GM Ecotec 2.0L/2.2L/2.4L I-4 Primary Chain

GM Ecotec 2.0L/2.2L/2.4L I-4 Primary Tensioner

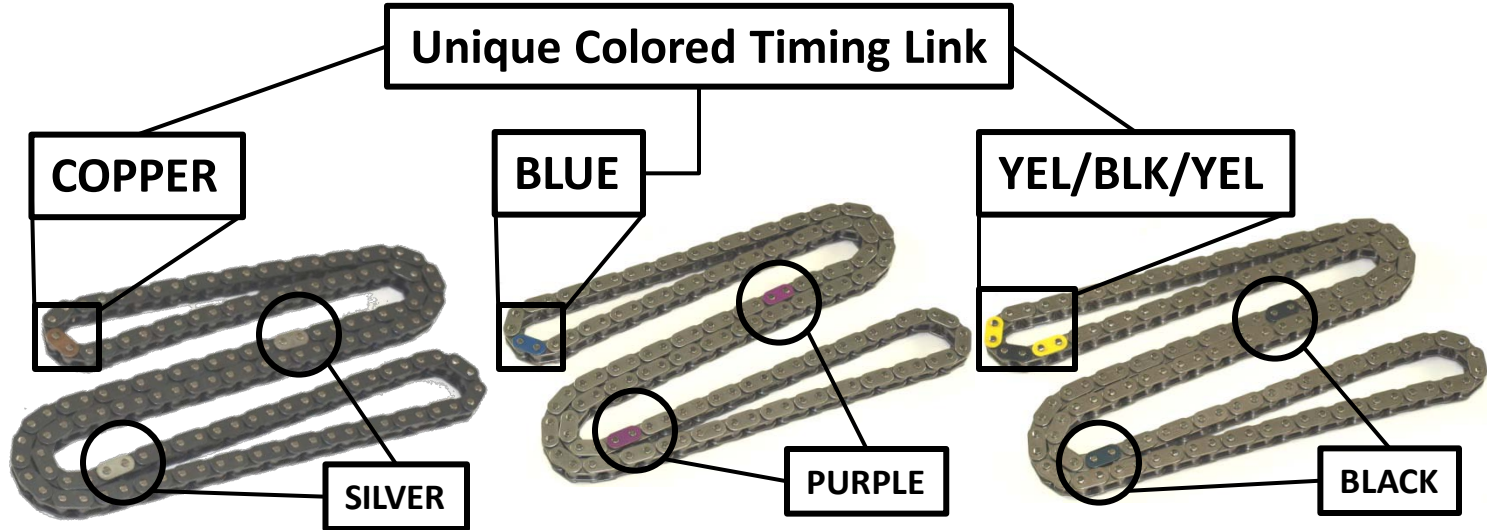
GM has had 3 different timing mark designs. The illustration below shows that no matter the timing mark color or arrangement, the placement on the chain is the same. **With all 3 designs the unique timing mark is aligned with the intake cam sprocket timing mark.**

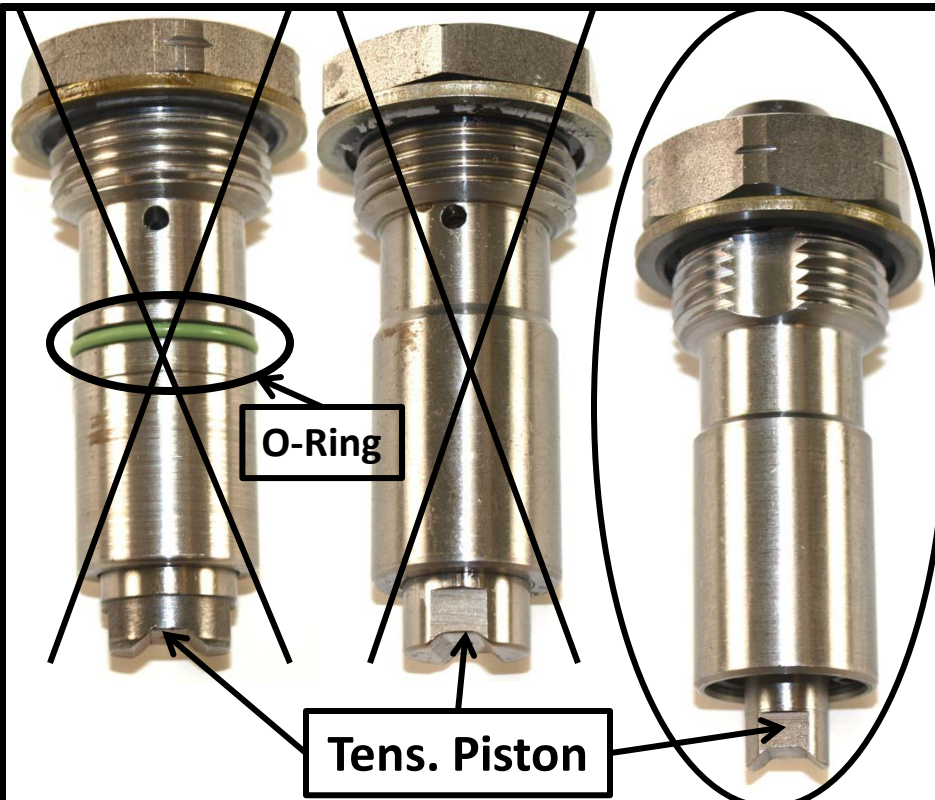
GM has had 3 different tensioner designs. The 1st design had a rubber O-ring, had a larger tensioner piston, and was a 2 piece design. The 2nd remained the same except had no O-ring. The **3rd supersedes all previous tensioners**, has no O-ring, has a smaller tensioner piston, and is one piece. This tensioner is shipped and installed deactivated and cannot be deactivated without disassembly. Tensioner is deactivated when the tensioner piston moves freely back and forth. **Do not install activated.**

GM Ecotec 2.0L/2.2L/2.4L I-4 Cadena Principal

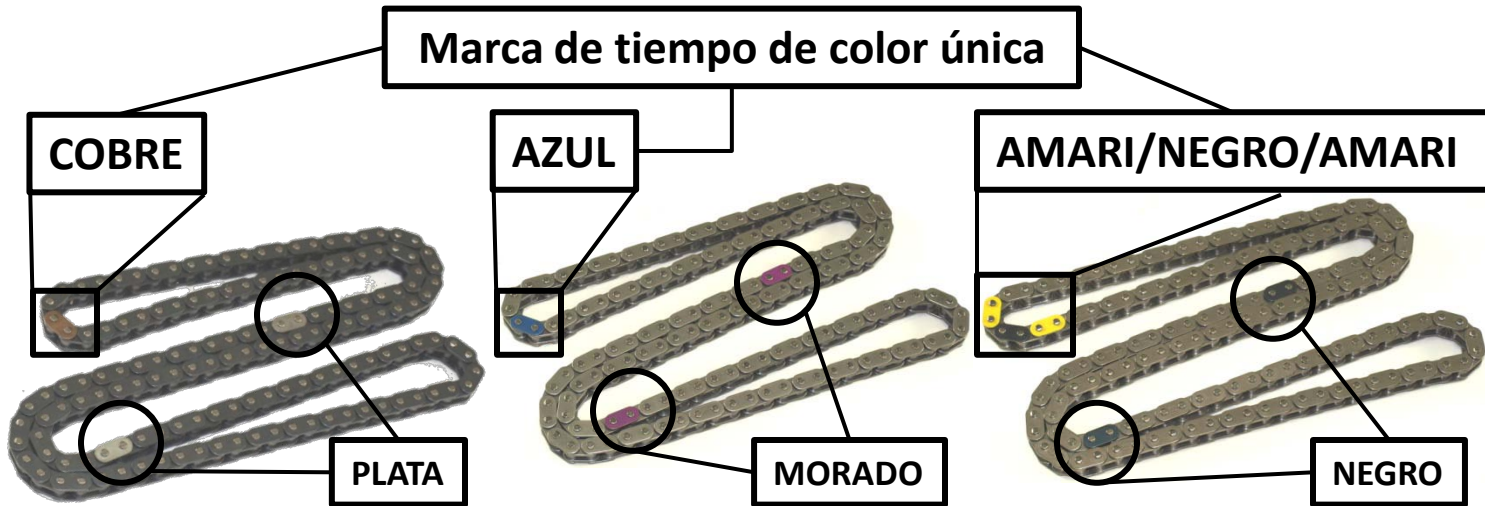
GM ha tenido 3 diseños de marcas de tiempo diferentes. La ilustración que se muestra a continuación indica que no importa el color o el arreglo de las marcas de tiempo, la colocación en la cadena es igual. **En los 3 diseños, la marca de tiempo única es alineada con la marca de tiempo del engrane que corresponde al árbol de levas de admisión.**

GM Ecotec 2.0L/2.2L/2.4L I-4 Tensor Principal

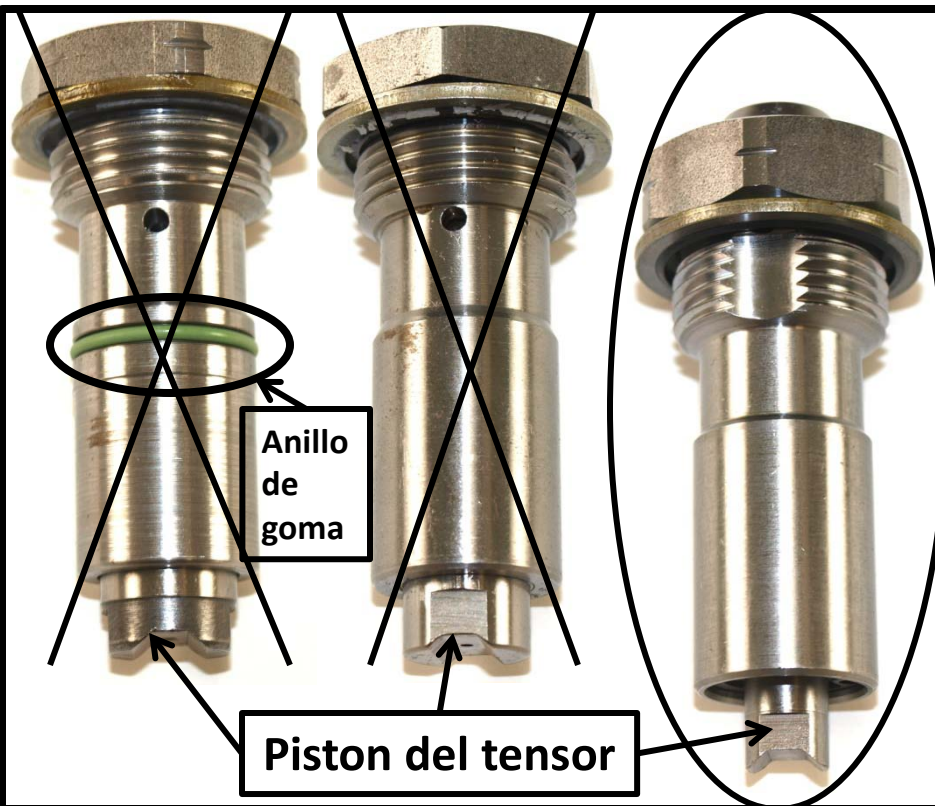
GM ha tenido 3 diseños diferentes del tensor. El primer diseño tenía un anillo de goma, el pistón del tensor era más largo y era un diseño de 2 piezas. El segundo era igual, excepto que no tenía el anillo de goma. **El tercero reemplaza a todos los tensores anteriores,** no tiene anillo de goma, el pistón del tensor es más chico y es solo una pieza. El tensor es enviado e instalado desactivado, y no puede desactivarse sin desarmarlo. El tensor es activado cuando el pistón se mueve fácilmente. **No instale el tensor activado.**
